ADDENDUM NO. 1

**INTERMOUNTAIN LAKE PARK NORTH LEVEL 1
REMODEL**

ADDENDUM NO. 2

Purpose for the Addendum: These changes resulted from design team clarifications and city plan review comments.

D2 ARCHITECTURAL POWER PLAN - LEVEL 1
 AP101 | SCALE: 1/8" = 1'-0"

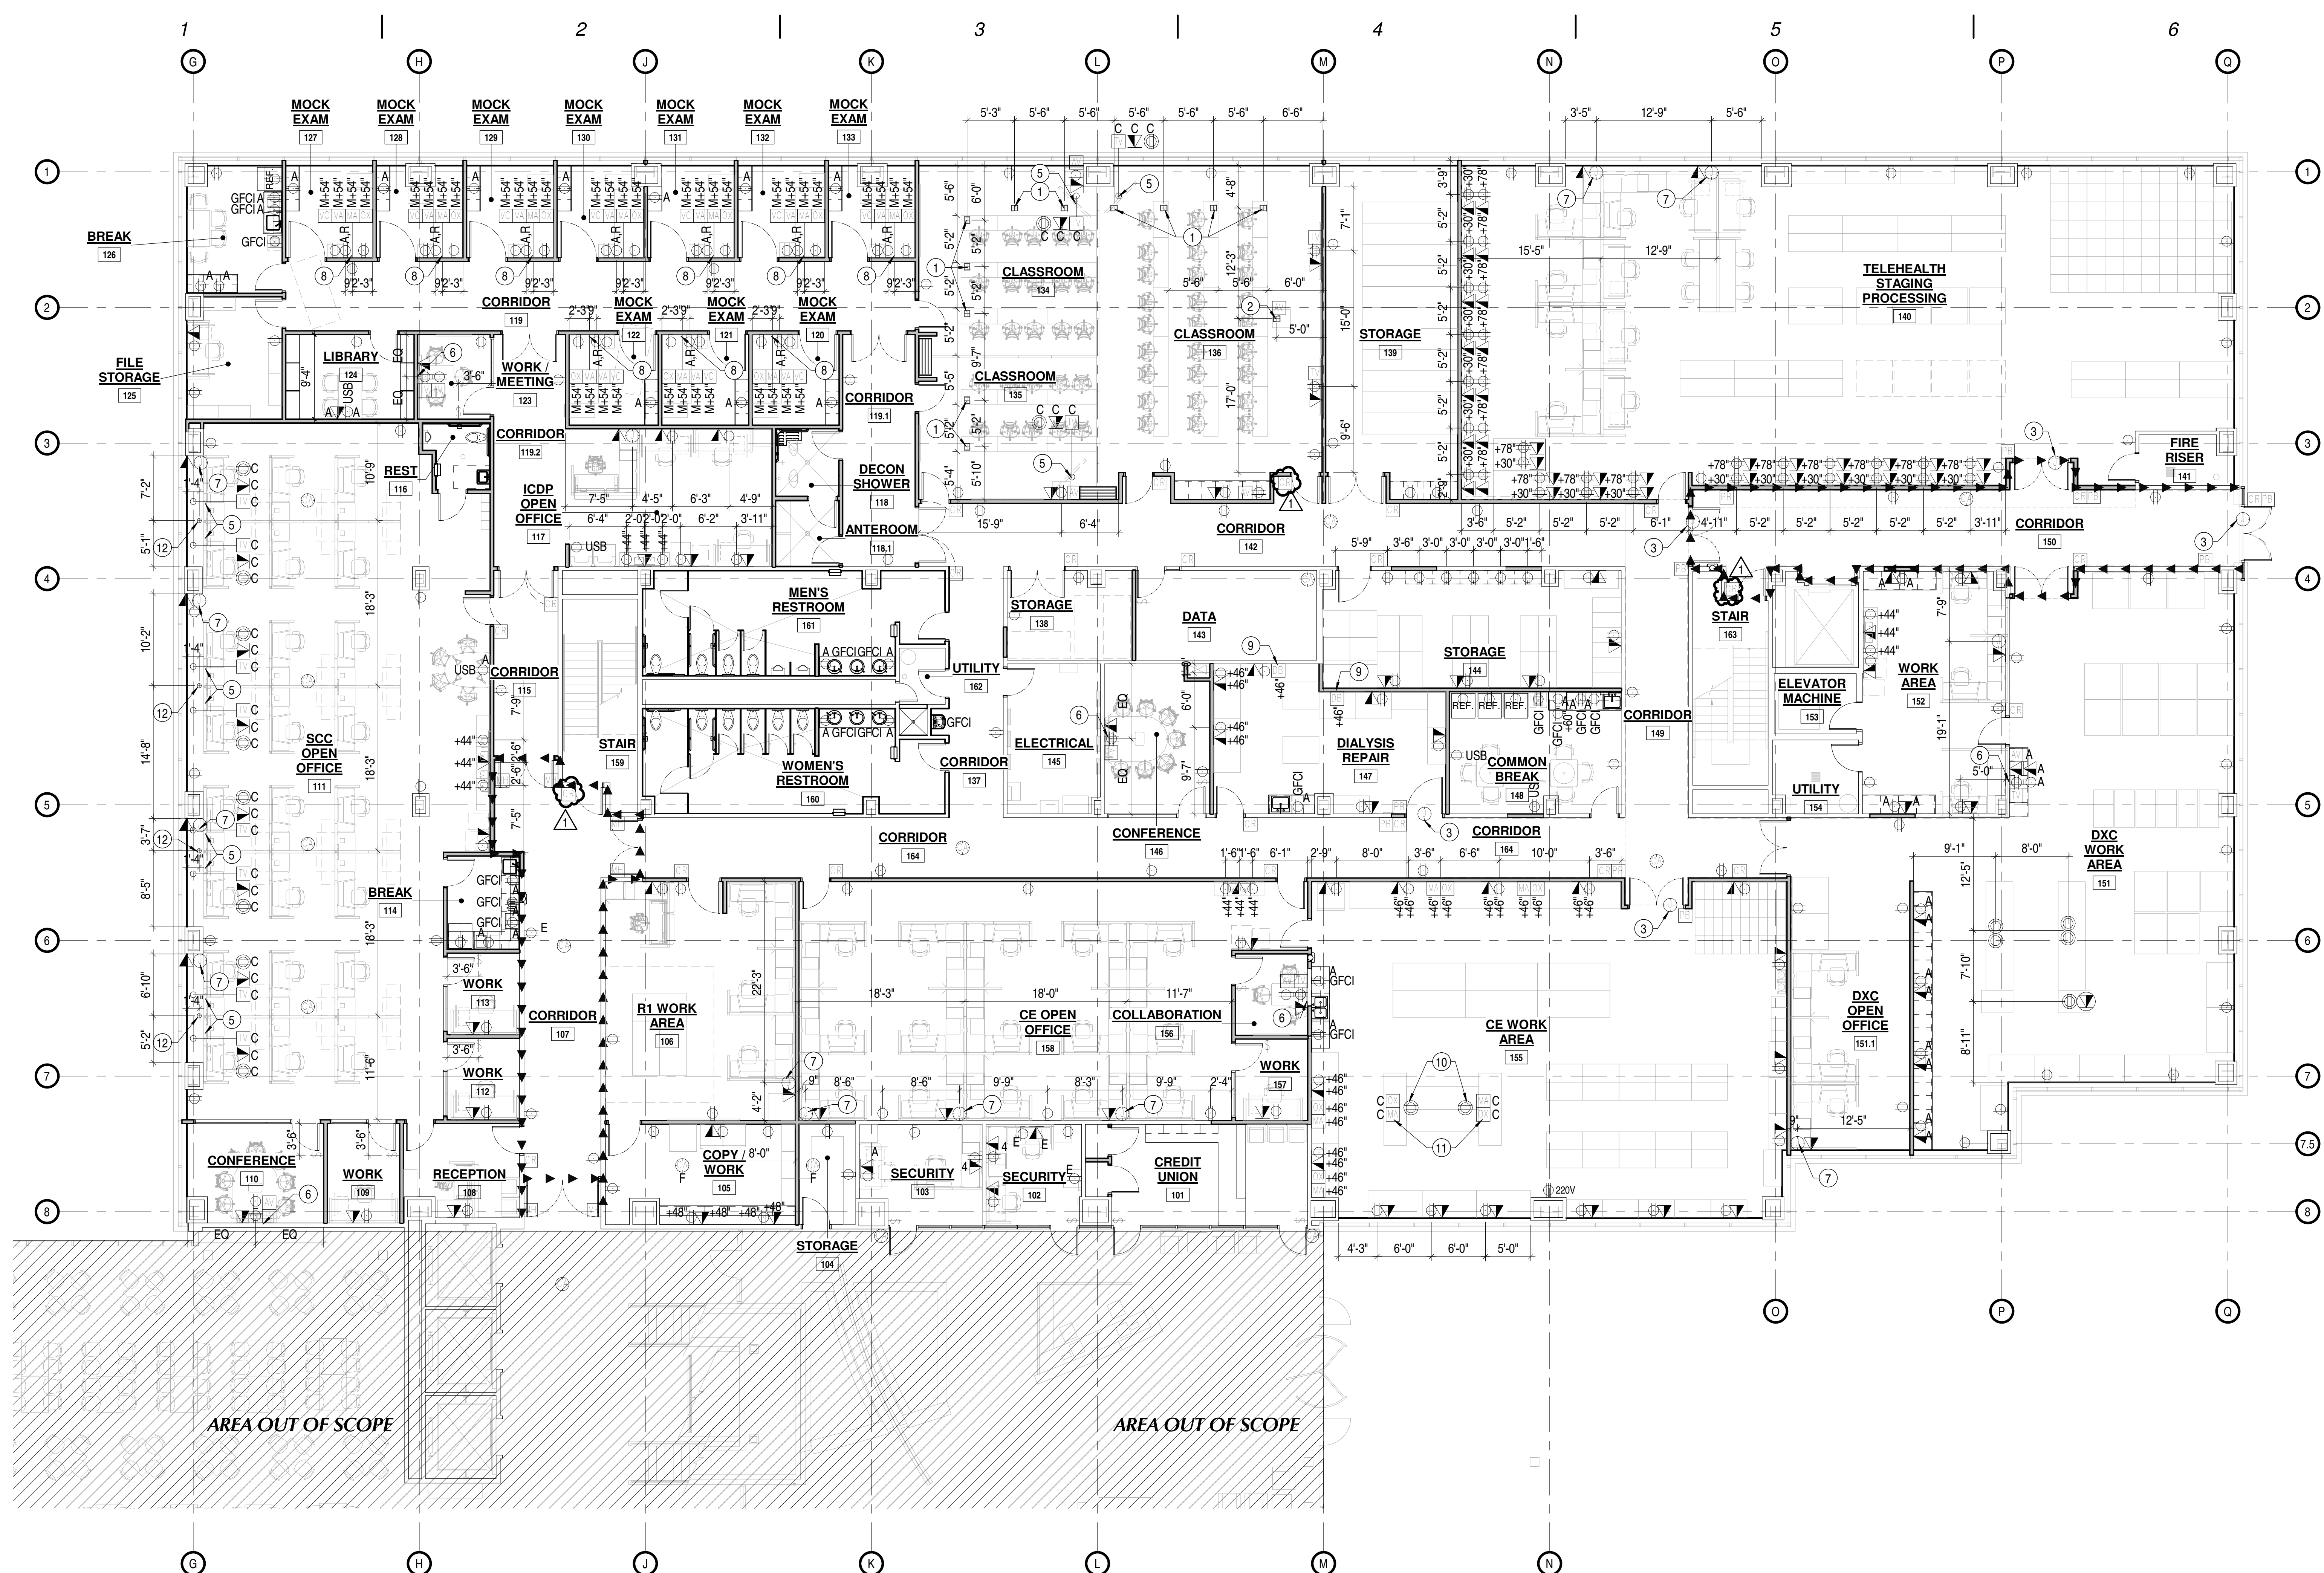
1. Some of the hardware will be provided and installed by the Owner's Access Control Company (Accent Automatics). Hardware sets have been modified to clarify scope. Other door modifications have been made as well. Please have bidders review all hardware sets. **See the revised spec section 08 7100 (hardware sets only), and the revised A601, AP101, and EP101.**

1 MECHANICAL PIPING PLAN LEVEL 1
 MP101 | SCALE: 1/8" = 1'-0"
 NORTH

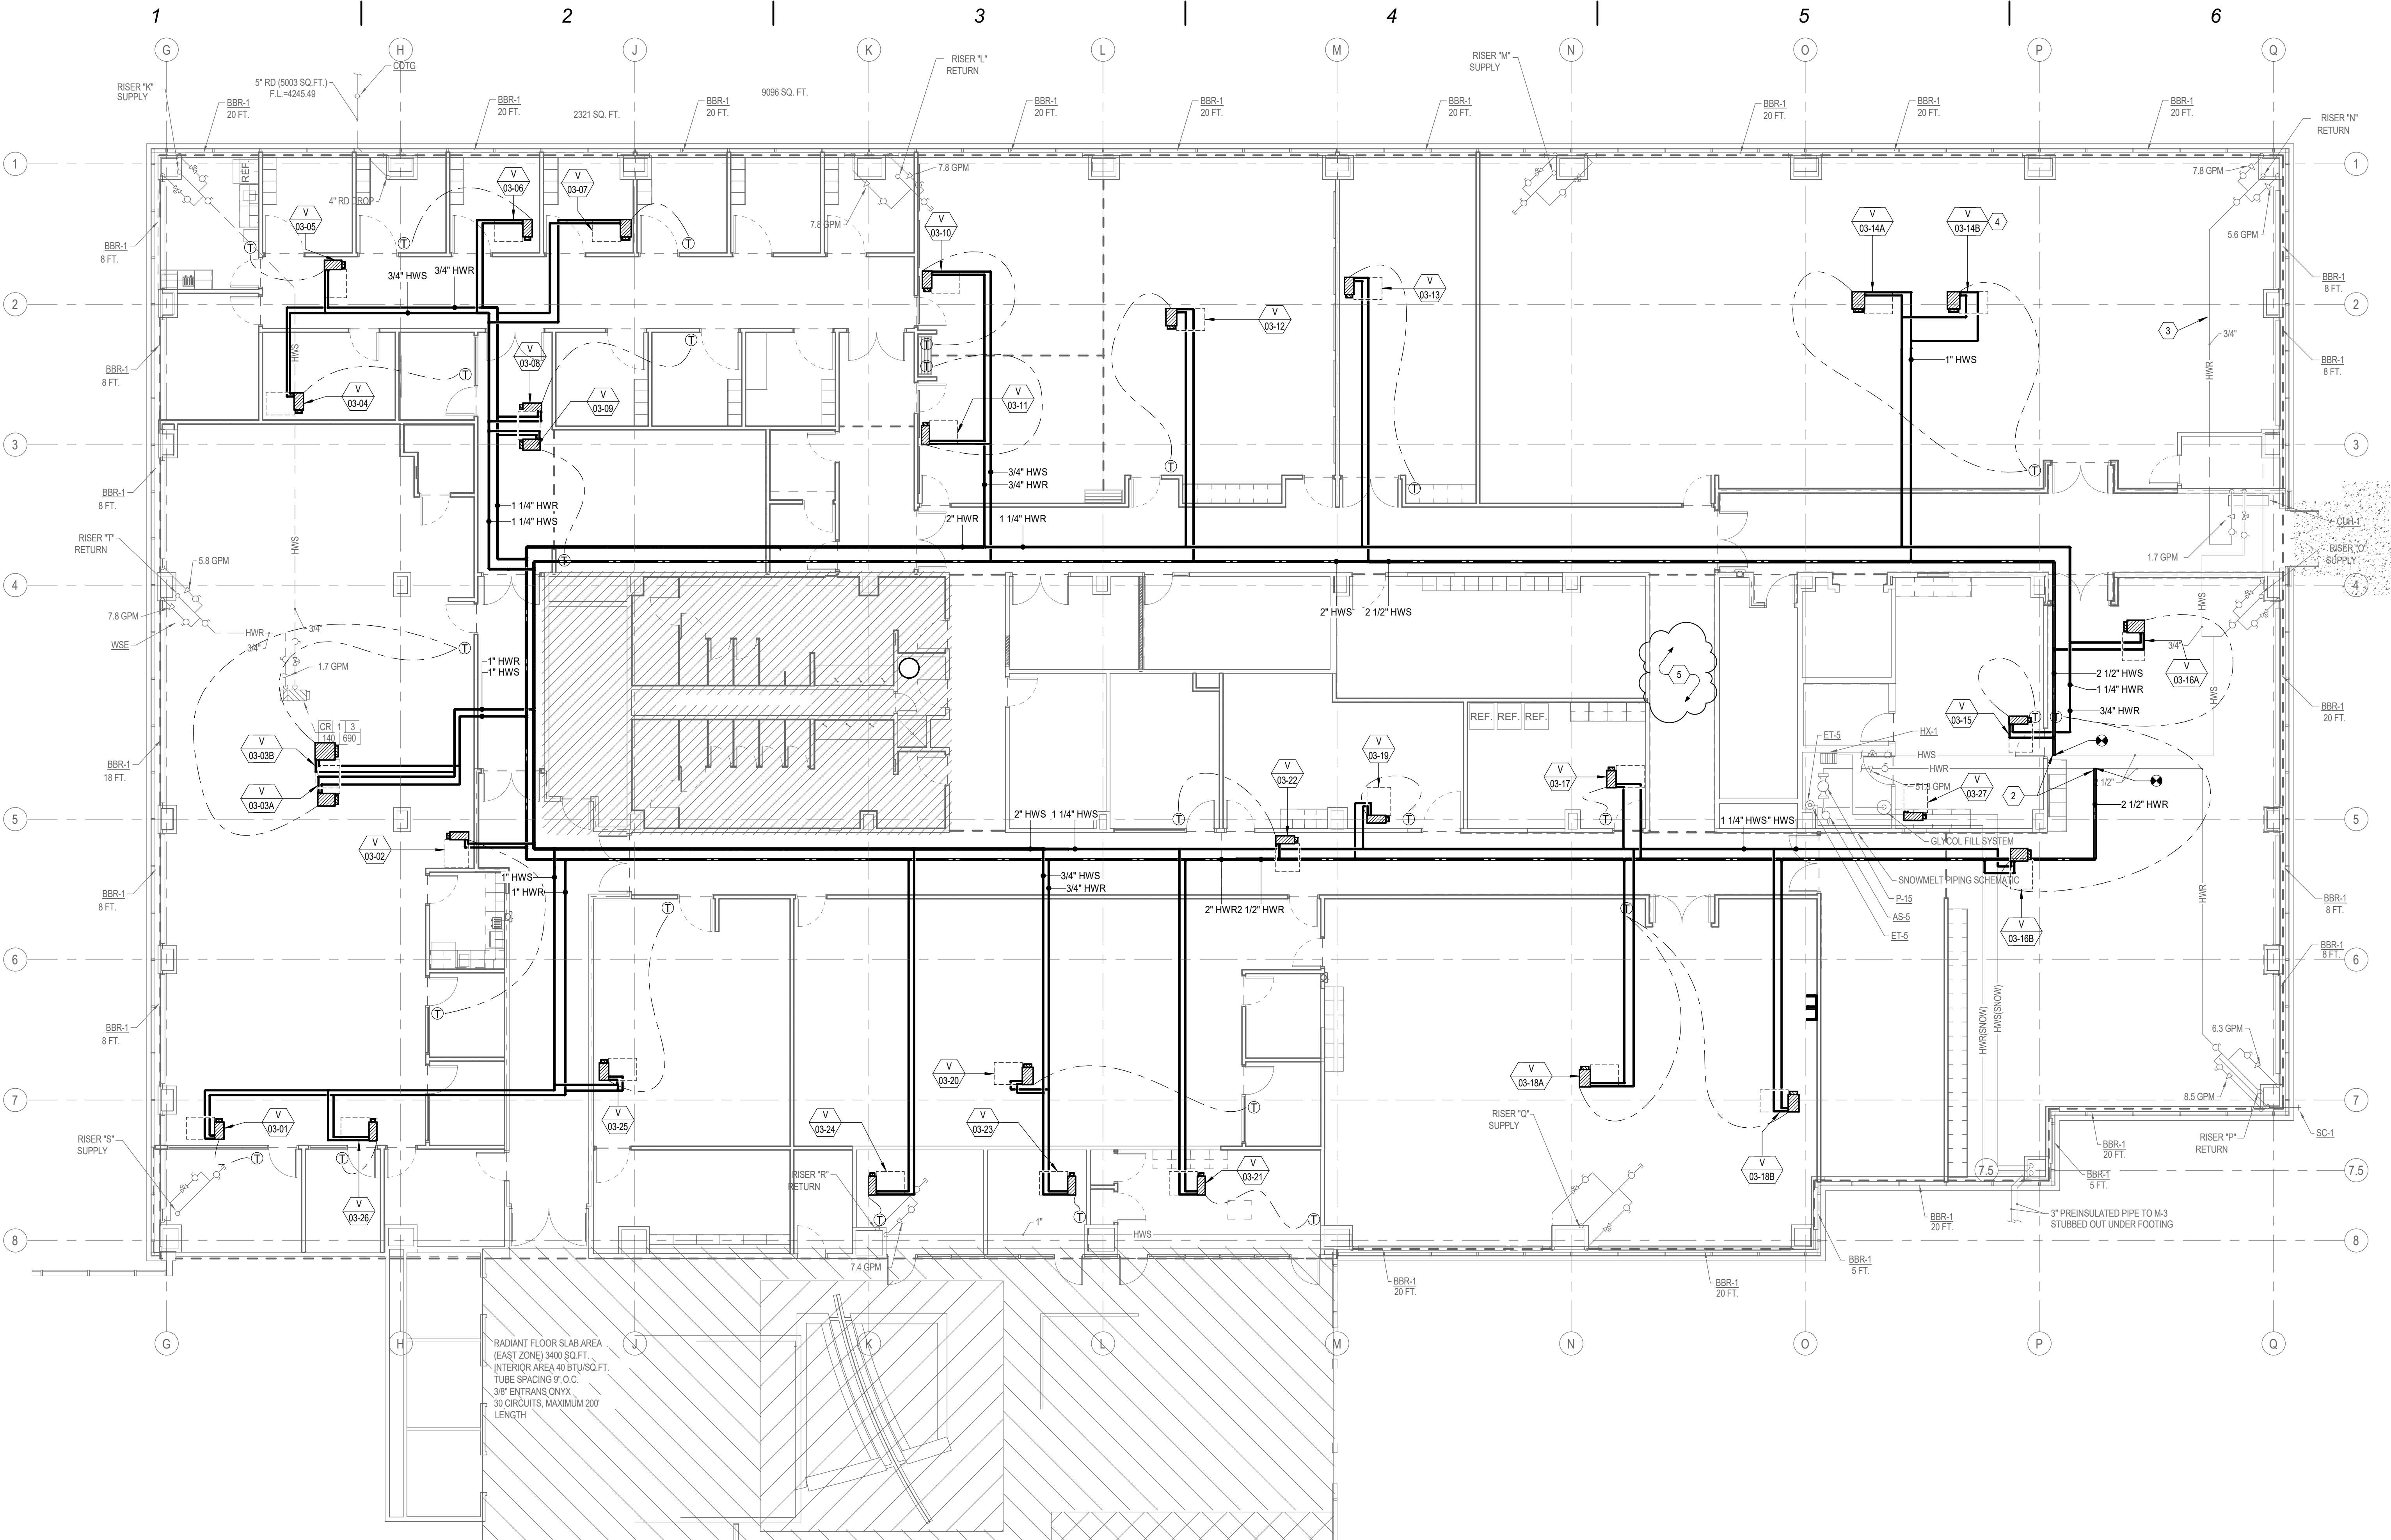
Sheet: MP101 - MECHANICAL PIPING PLAN LEVEL 1

- Keyed note 5 added.

1 PLUMBING PLAN LEVEL 1
PP101 | SCALE: 1/8" = 1'-0"

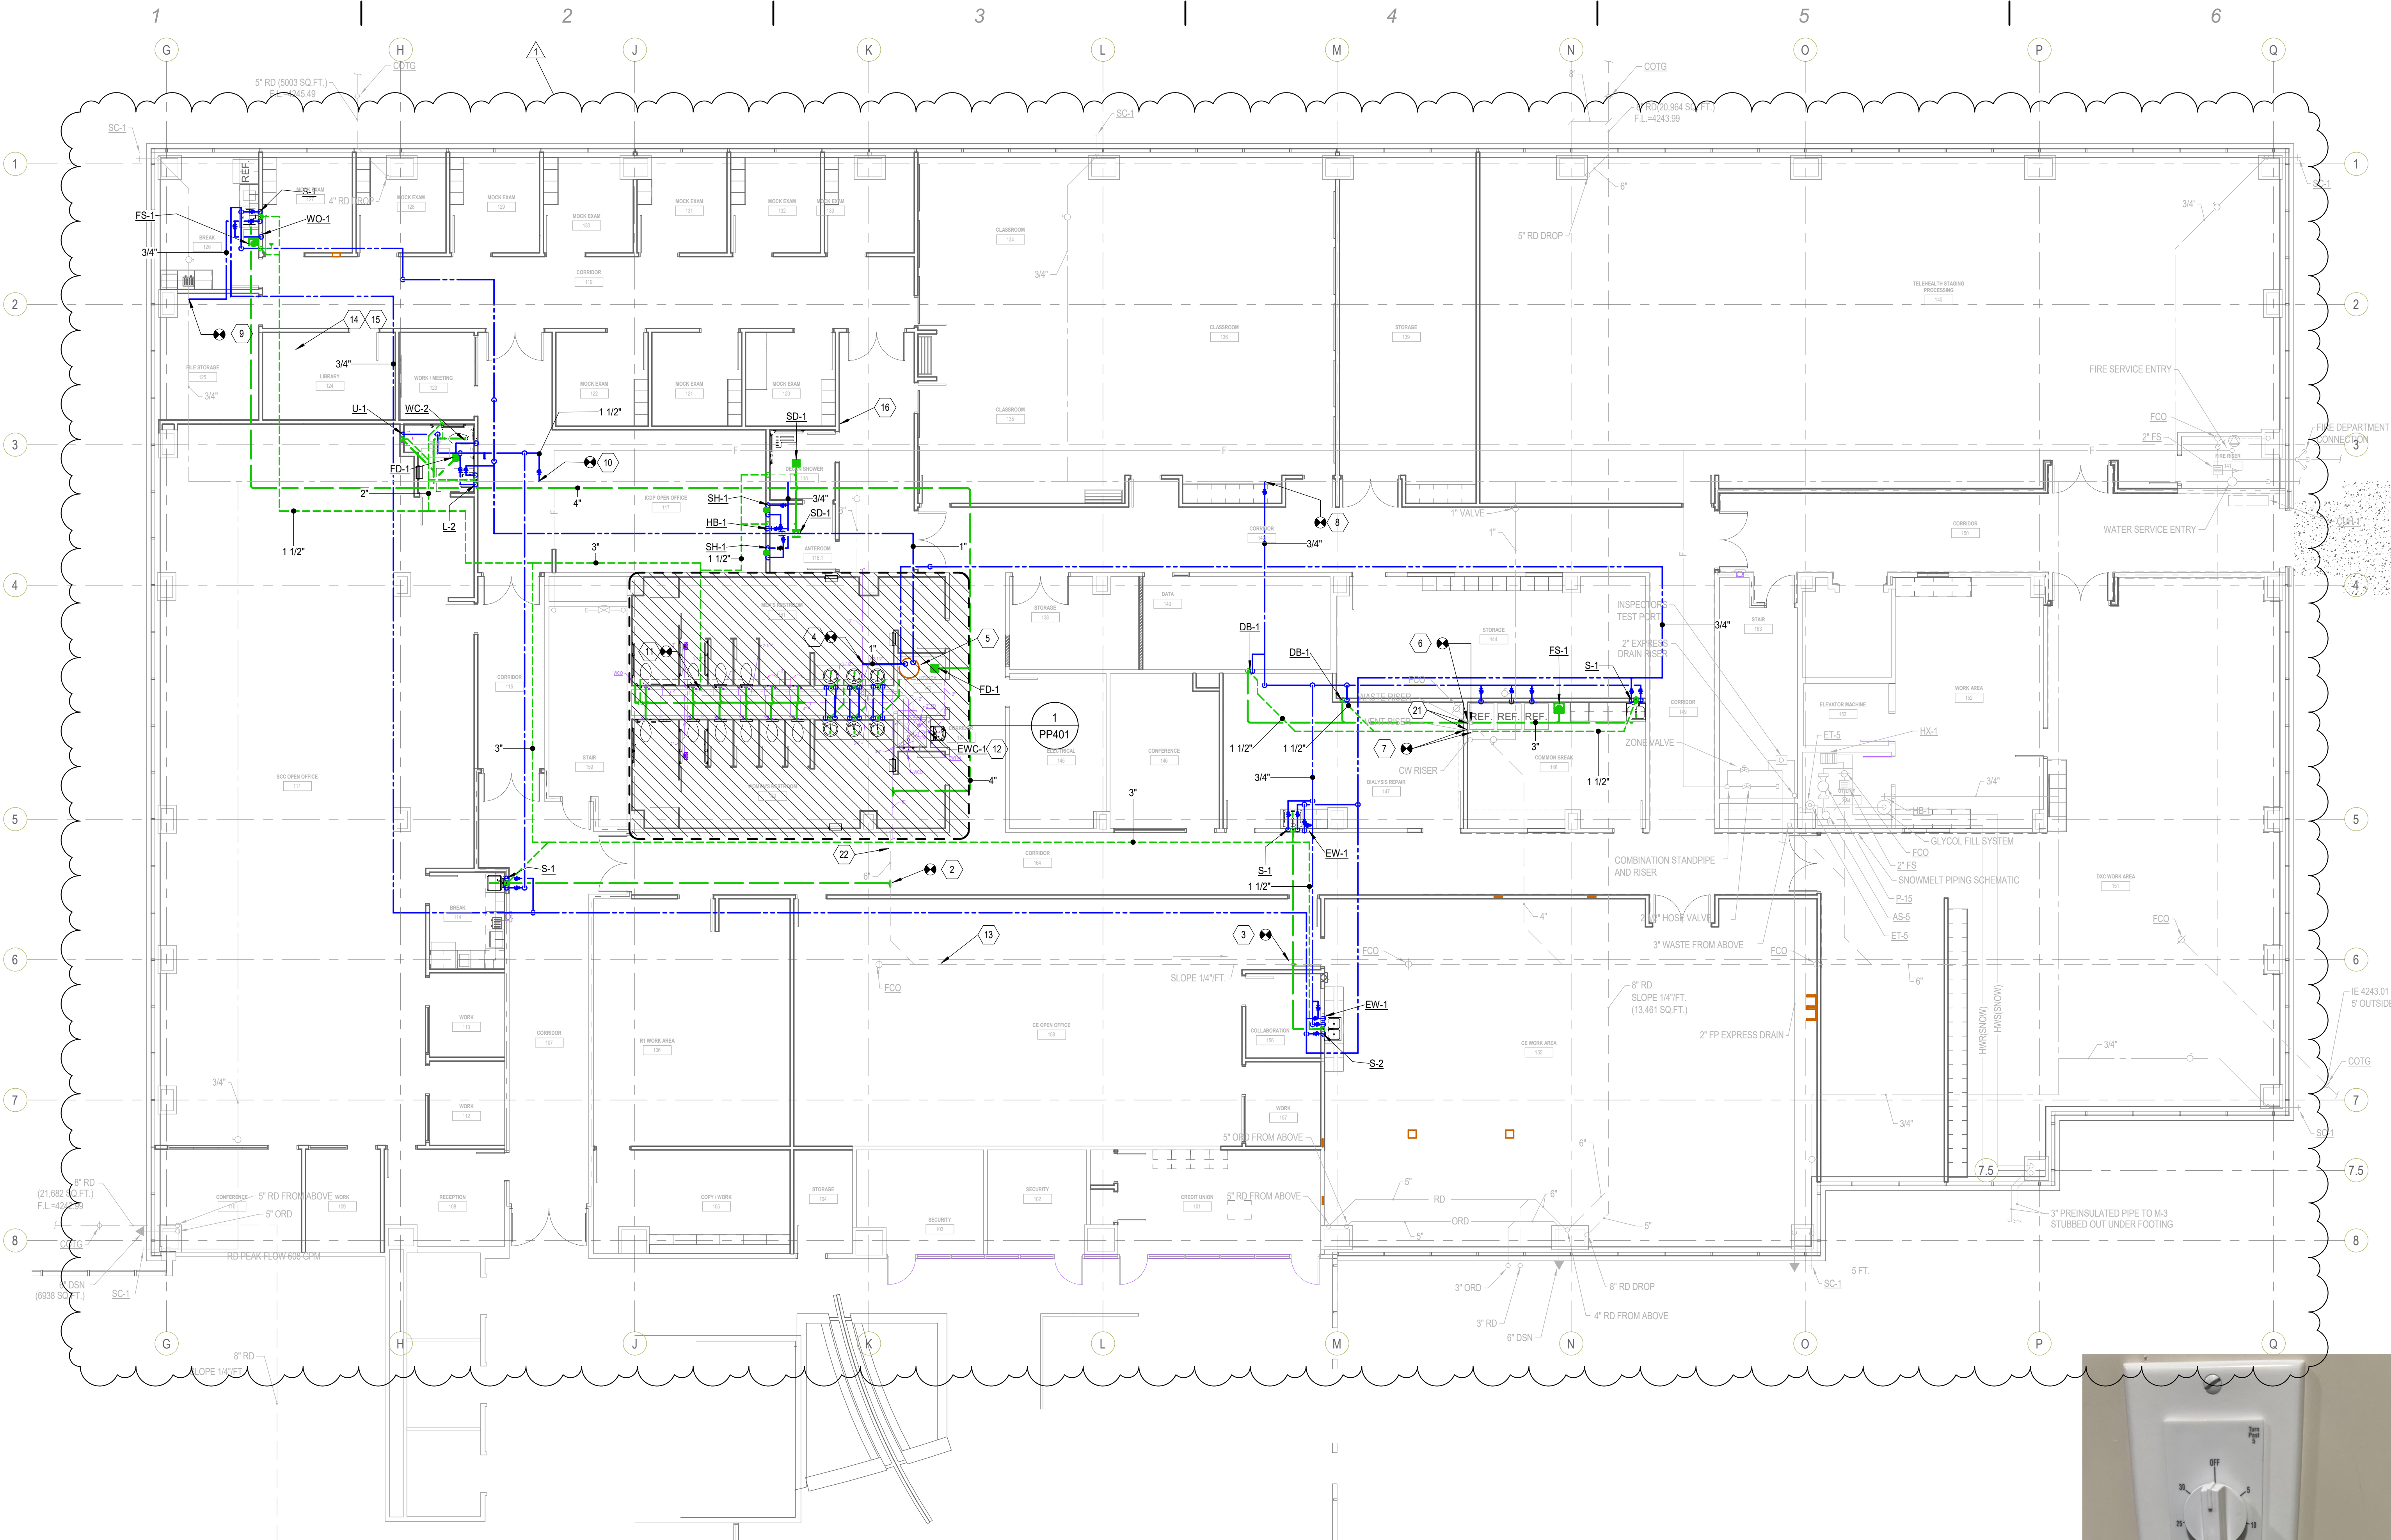
Sheet: PP101 - PLUMBING PLAN LEVEL 01

- Keyed notes 22 and 23 added.
- Pipes colored at the request of the sewer district.
- Keyed note 19 updated.
